**ADDENDUM 1**

USC Close-Hipp Building: Grid Ceiling Installation for 6th and 7th Floors

Project # 50003342-3 H27-Z387

|           |  |  |  |  |  |  |  |  |  | DRAWN BY        |  | CHECKED BY           |  | FINAL APP.         |  |                     |  | GMK INC.  |  |            |  | 6th FLOOR<br>REFLECTED CEILING PLAN |  | PHASE II<br>COLLEGE OF<br>BUSINESS ADMINISTRATION |  |               |  |

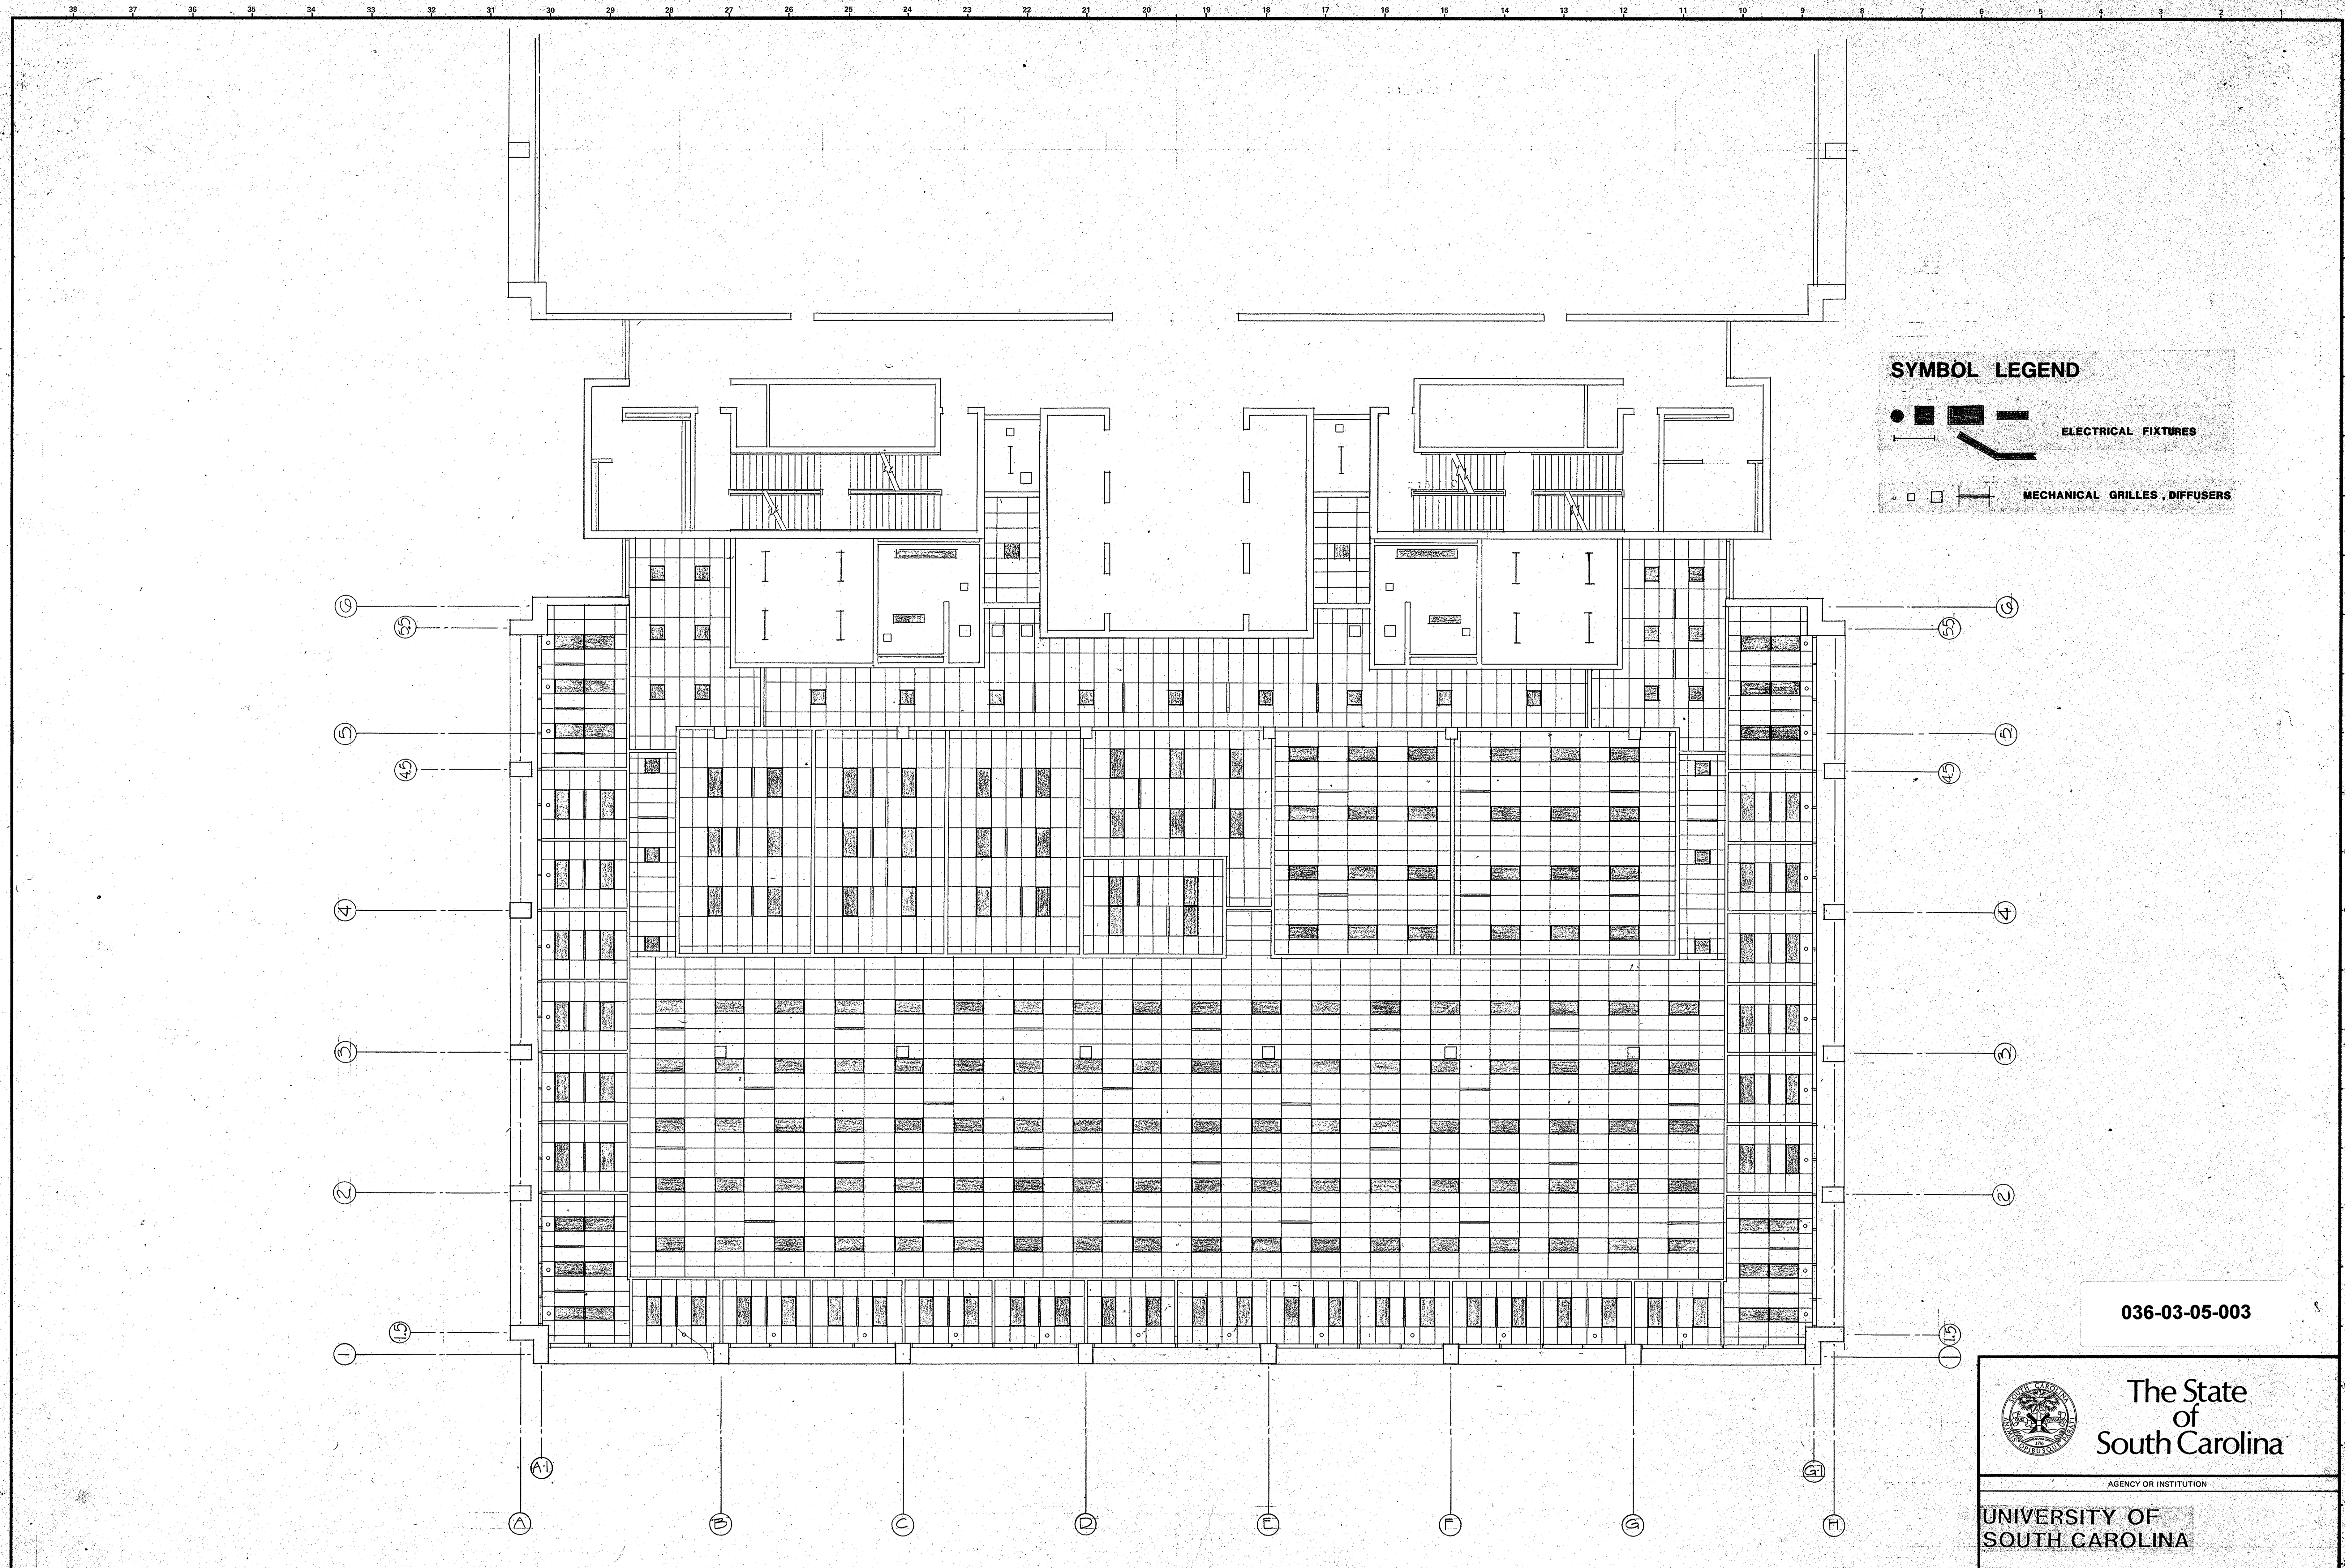
4. Q: Clarify where the 2x4 vs the 2x2 tile was installed originally.

A: Bidders should assume that 2x2 tiles were used in the Close and Hipp corridor areas, elevator lobby and stair lobby areas. Bidders should assume that 2x4 tiles were used everywhere else. Original reflected ceiling plans for Hipp side floors 6 and 7 are attached for reference. Please note that there are some 2x2 fixtures shown within the open spaces but it is believed these were mounted within a 2x4 grid. After award, the successful bidder is to double check this information against where the walls are marked and quantity adjustments will be made at that time, if appropriate.
